**A556 Knutsford to Bowdon Improvement Scheme
Local Impact Report
Executive Summary**

Prepared by Cheshire East Council August 2013

IPC Reference Number TR010002

Appendix B Millington roundabout (slip from A556, de-trunked A556 and Cherry Tree Link)

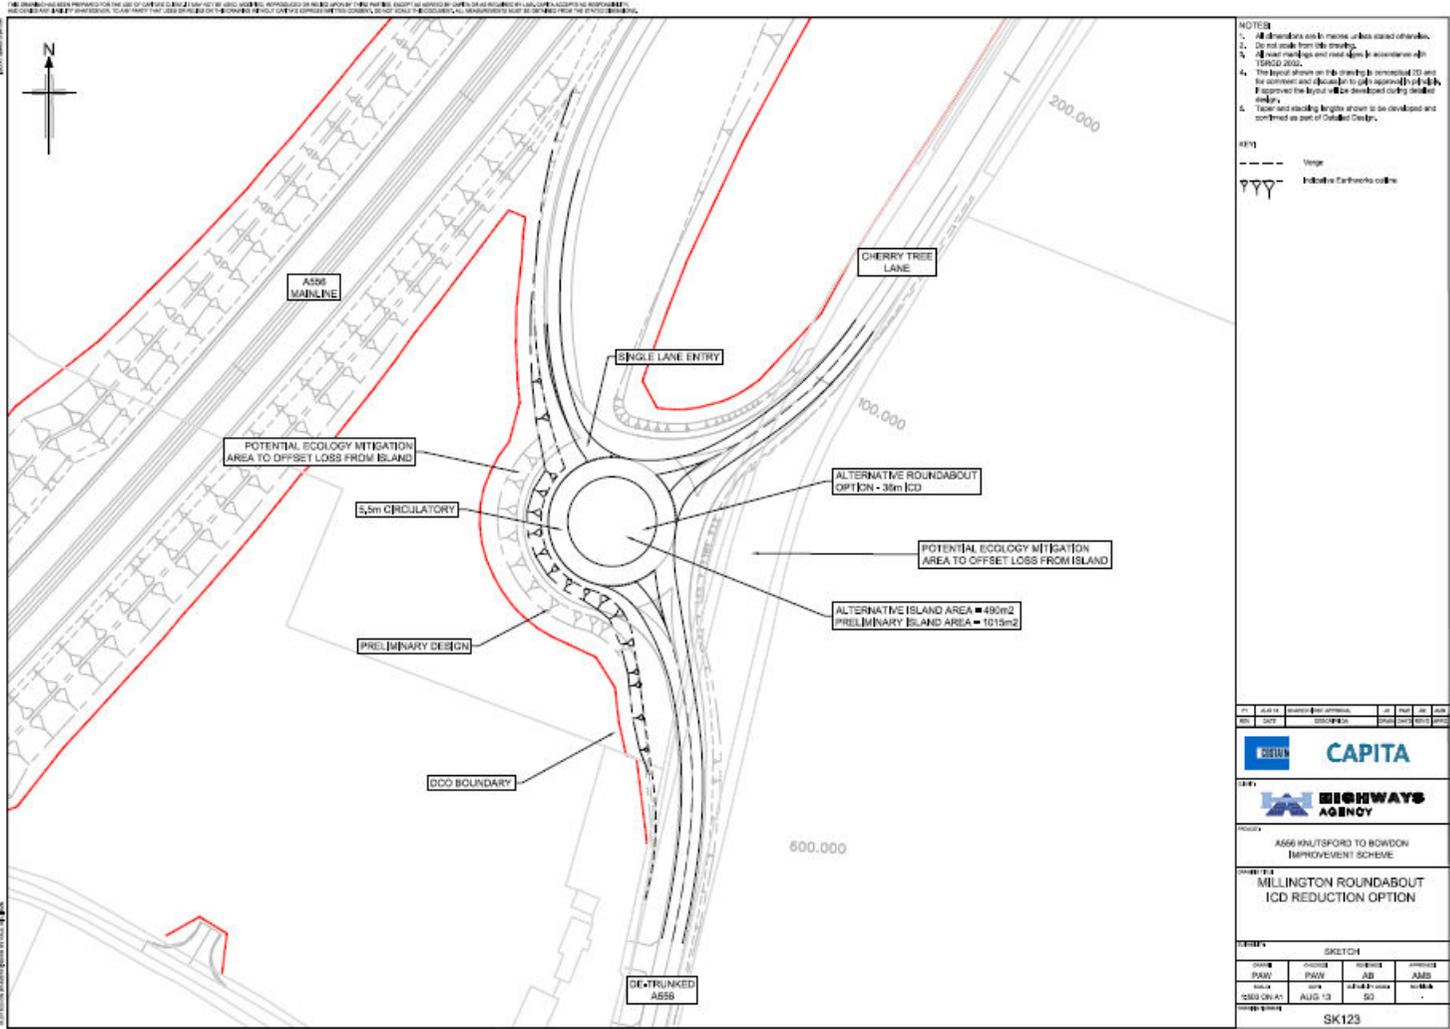
4.13 At the new Millington Junction (Appendix B), a crossing for pedestrians, cyclists and horse-riders would be provided just south of the junction, incorporating corrals for horseriders, but without signal controls. A crossing without signals would also be provided on the de-trunked road just to the north of the roundabout. A revised junction design for the roundabout has been presented by the HA to CEC that needs to be agreed by the end of the examination in public.

Appendix C A50 / new A556 roundabout junction

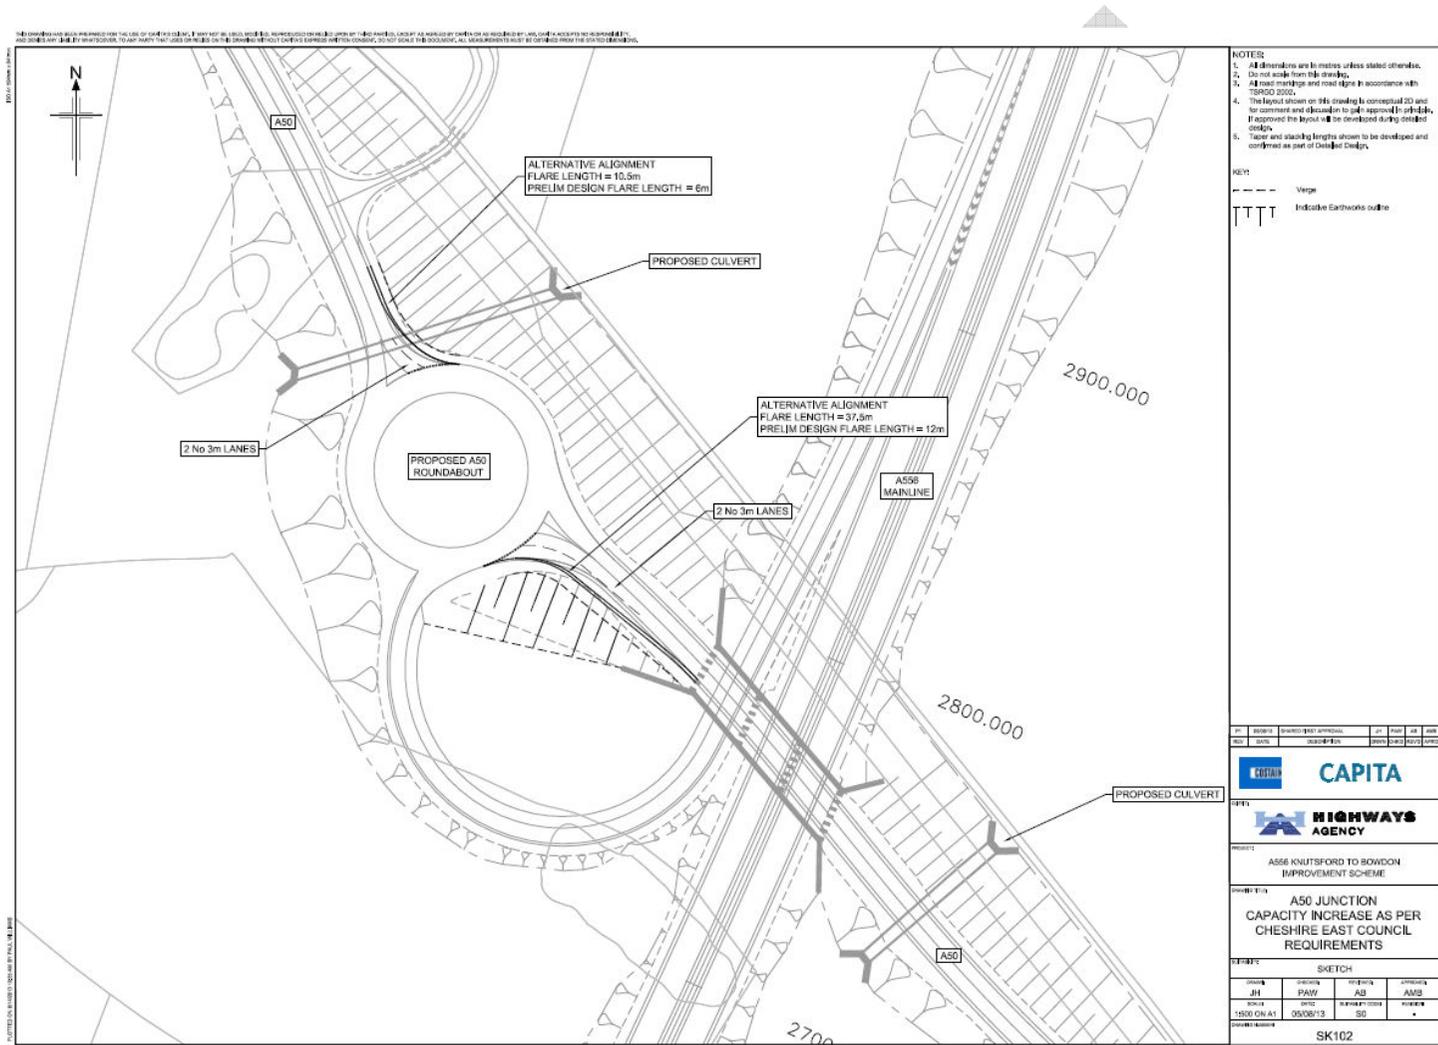
4.9 A50 / new A556 junction – CEC have concerns over the design of this new junction that have not yet been resolved. Initial assessments by CEC using flows supplied by the HA indicate that significant queues would be generated in the morning peak on the southbound A50 approach to the roundabout in the 2032 design year – this is without additional traffic stress caused by Motorway incidents. A revised design is presented in Appendix C

DATE	ISSUED	DESIGNED	CHECKED	APPROVED
PROJECT: A556 KNUTSFORD TO BOWDON IMPROVEMENT SCHEME				
DRAWING TITLE: A50 JUNCTION CAPACITY INCREASE AS PER CHESHIRE EAST COUNCIL REQUIREMENTS				
DRAWING TYPE: SKETCH				
DESIGNED	CHECKED	APPROVED	DATE	SCALE
JH	PAW	AB	AM2	
DATE	DATE	DATE	DATE	DATE
18/01/2011	08/08/13	10		
DRAWING NUMBER: SK102

Appendix D Proposed layout for A50 /de-trunked A556 Mere crossroads

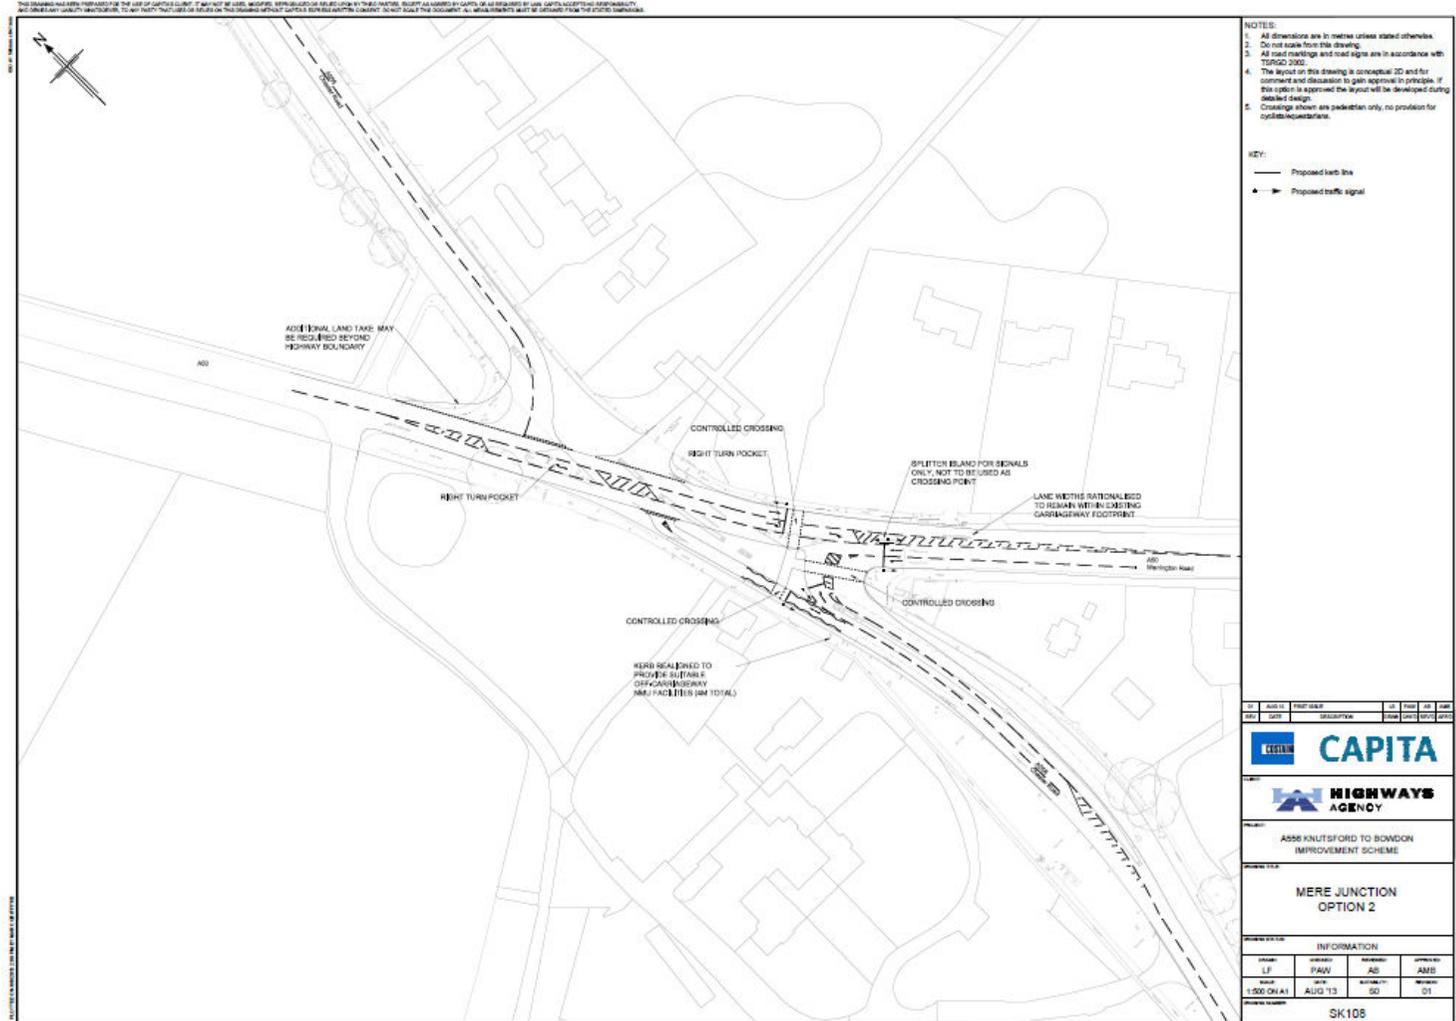
4.10 There are two existing signalised junctions within the section of Chester Road that is to be de-trunked – with the A50 at Mere Crossroads and with the A5034 at Bucklow Hill Junction. Both junctions would be modified, see Appendix D for further details of Mere crossroads and Appendix E for Bucklow Hill. Initial designs were considered by CEC and suggested amendments to the designs were made to address concerns (as presented in the appendices).

4.11 At the A50 / de-trunked A556 junction in Mere (Mere Crossroads) in the current proposals the A50 would become the main through route. The initially proposed junction arrangement may not be adequate. The de-trunked Chester Road would be realigned at the junction to form two T-junctions onto the A50, offset from each other. CEC are looking for network resilience to cater for additional traffic that might be generated by events at Tatton Park and during incidents on the M6 that force traffic to divert onto the A50 / de-trunked A556. Existing restrictions on right-turning movements would be lifted, so that all turns would be possible. CEC are working with the HA to devise an alternative design and alternative signal timings to be instigated when incidents occur on the M6, that may be able to address these concerns. The junction would continue to be partially controlled by traffic light signals. Signals would be retained at the southern junction to include provision for pedestrians, horse-riders and cyclists crossing the A50.
